#### 197th session

## **Proposal for Supplement 22 to the 06 series of amendments to UN Regulation No. 48 (Installation of Lighting and Light- Signalling Devices)**

### **Submitted by the Working Party on Lighting and Light-Signalling\***

6.27.3. Arrangement

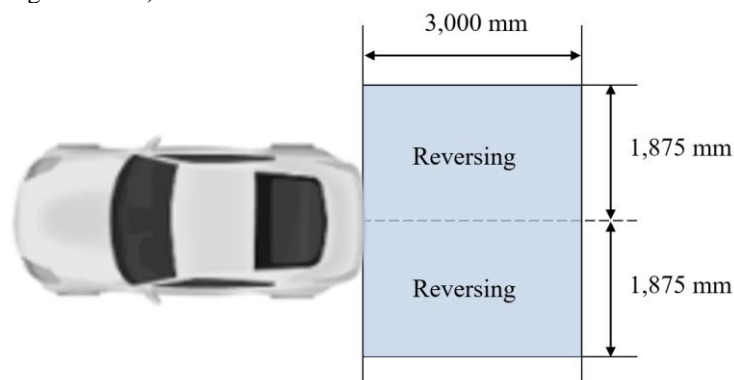
Such that the provisions of paragraphs 6.27.5., 6.27.6. and 6.27.9. are fulfilled.

6.27.5. Projection area

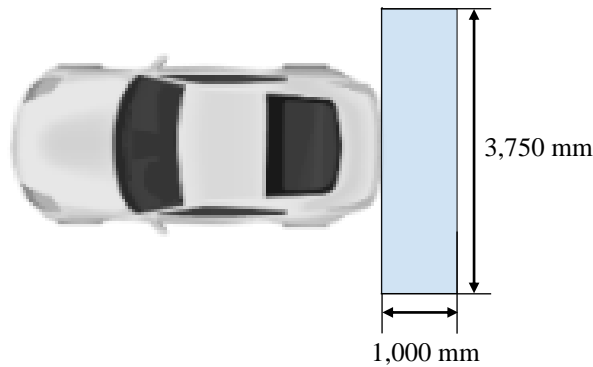
6.27.5.1. The lateral distance from the outer edge of the projection with respect to the longitudinal plane of the vehicle shall not be more than 1,875 mm.  
The longitudinal distance from the farthest edge of the projection shall not be more than 3,000 mm from the backward extreme outer edge of the vehicle (see figure below).
